1HZ AND 1HD-T ENGINES

■ DESCRIPTION

► 1HZ Engine (Manual Transmission Model) ◀

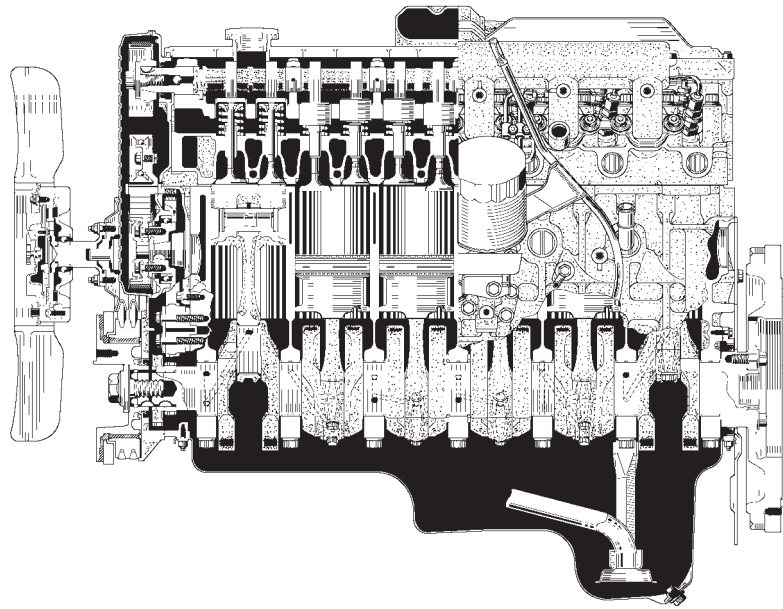
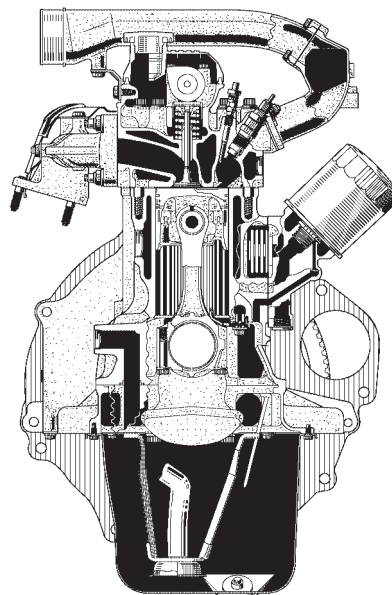
In the 1HZ engine, the injection nozzles have been changed and the shape of the combustion chamber has been changed to reduce exhaust emissions and the rigidity of the cylinder block has been improved to reduce noise and vibration. Similar to the 1HZ engine, the rigidity of the cylinder block of the 1HD-T engine has been improved to reduce noise and vibration.
